The Commission has issued the enclosed Amendment No. 97 to Facility Operating License No. DPR-51 for Arkansas Nuclear One, Unit No. 1 (ANO-1). This amendment consists of changes to the Technical Specifications (TSs) in response to your application dated March 1, 1985.

The amendment revises the ANO-1 TSs to reflect specific time intervals in terms of Effective Full Power Days for Axial Power Shaping Rod insertion limits.

ATTACHMENT TO LICENSE AMENDMENT NO. 97

SAFETY EVALUATION BY THE OFFICE OF NUCLEAR REACTOR REGULATION  
SUPPORTING AMENDMENT NO. 97 TO FACILITY OPERATING LICENSE NO. DPR-51  
ARKANSAS POWER & LIGHT COMPANY  
ARKANSAS NUCLEAR ONE, UNIT 1  
DOCKET NO. 50-313

APSR Position Limits for Operation From  
0 EFPD to 400 + 10 EFPD --- ANO-1  
Figure 3.5.2-4A

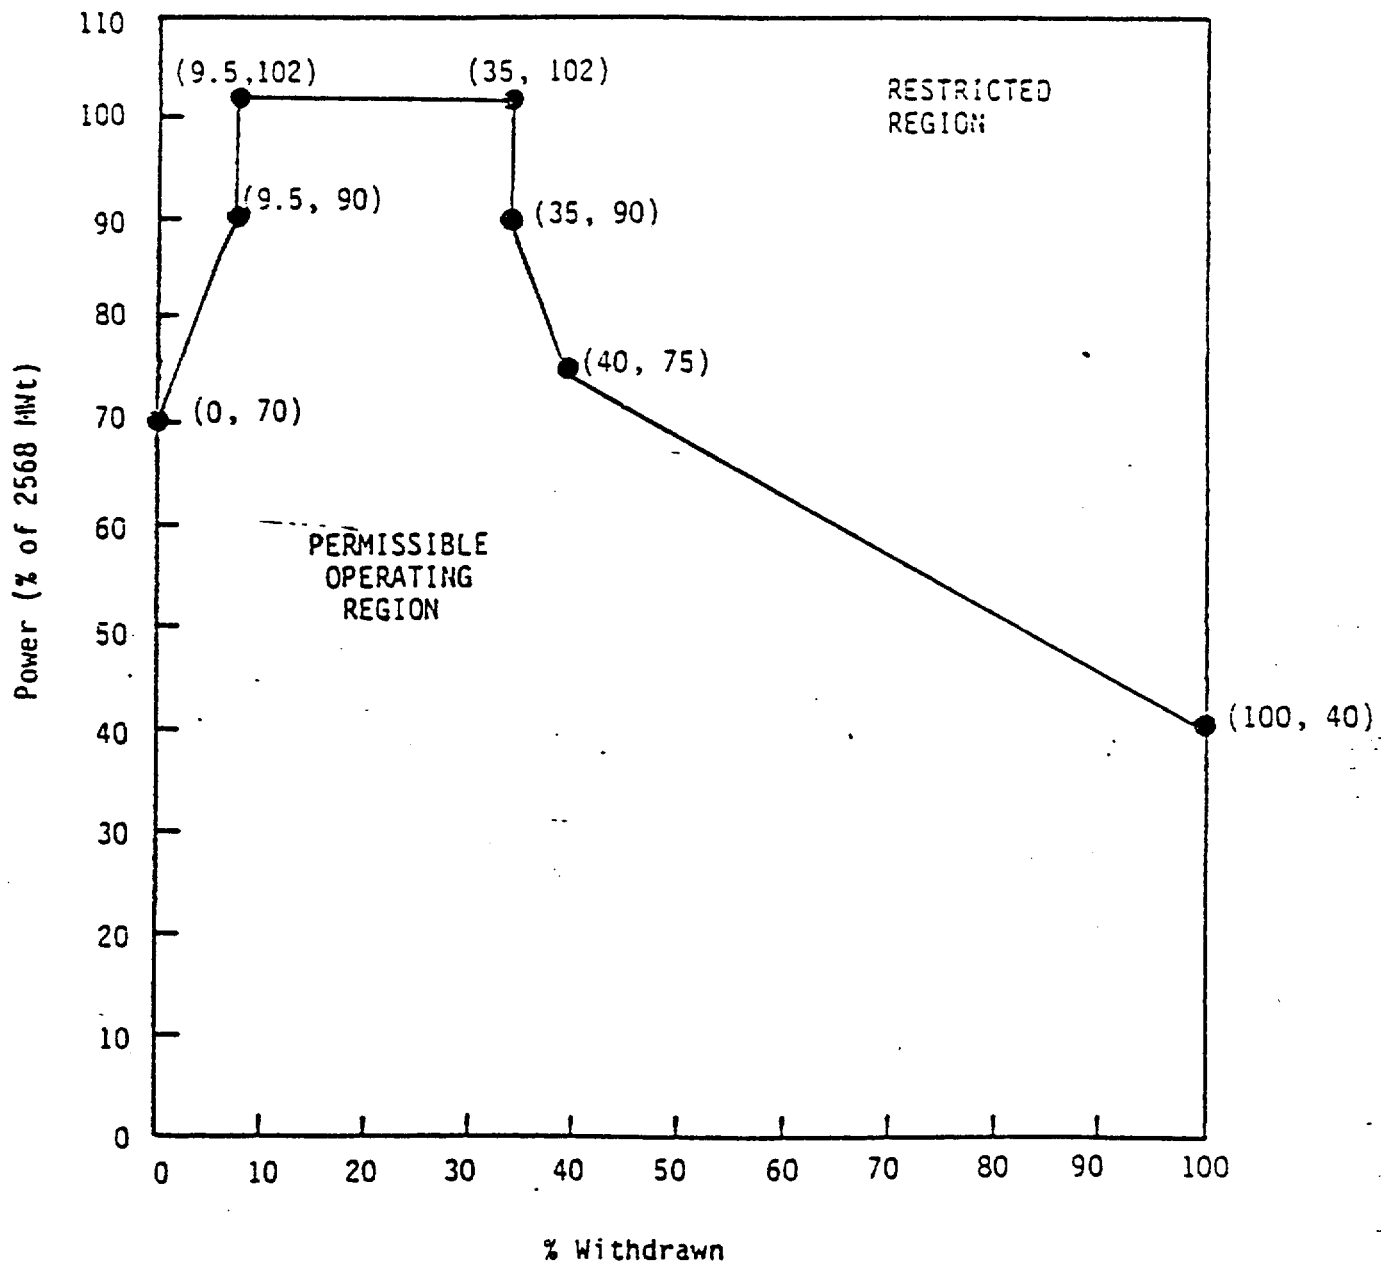
In our review of the AP&L application for amendment for the ANO-1 TSs for operation during Cycle 7 (Ref. 1), we noted that TS Figure 3.5.2-4A, "APSR Position Limits for Operation from 0 EFPD to APSR Withdrawal," did not provide a specific time during the cycle of operation when the APSRs would be fully withdrawn. This specific time interval has normally been provided in the TSs for previous cycles of operation. We, therefore, requested a revision to the ANO-1 TSs to reflect specific time intervals in terms of EFPD for APSR insertion limits (Ref. 2).

In response to our request, AP&L submitted proposed revised titles to TS Figures 3.5.2-4A and 3.5.2-4B which would govern APSR position limits from 0 EFPD to  $400 \pm 10$  EFPD and after  $400 \pm 10$  EFPD respectively. The calculated stability index at 404 EFPD without APSRs was shown to be  $-0.52h^{-1}$  in the Cycle 7 reload submittal (Ref. 4). This demonstrates the axial stability of the core without APSRs beyond  $400 \pm 10$  EFPD and the revised TS figure titles mentioned above, which refer to APSR removal beyond  $400 \pm 10$  EFPD, are therefore acceptable.
